Subject: N202313410 - Service Update Engine Wiring Harness Clip

Models: 2020 Chevrolet Malibu

Service Update N202313410 Engine Wiring Harness Clip

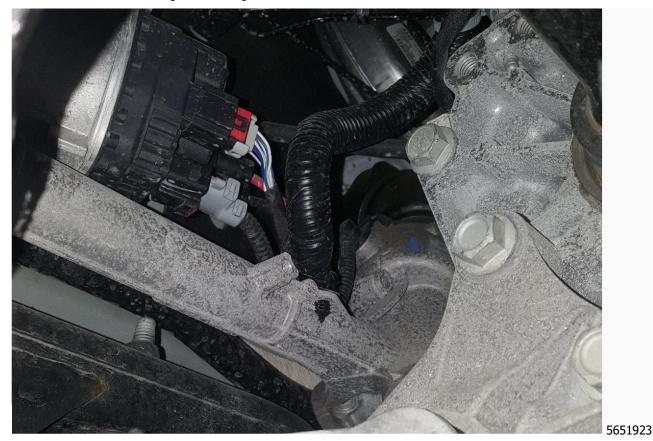
Condition	Certain 2020 model year Chevrolet Malibu vehicles may have a condition where the engine wiring
	harness clip may not be secured to the power steering gear housing.
Correction	Dealers are to secure the harness clip at the power steering gear.

2. Inspect the engine harness branch where it clips into the Power Steering rack as shown.

- If the engine harness is clipped into the rack, no further action is required.
- If the engine harness is not clipped into the rack, secure the harness to the rack using the push pin fastener attached to the harness as shown.
- 3. Lower the vehicle. Refer to *Lifting and Jacking the Vehicle* in SI.
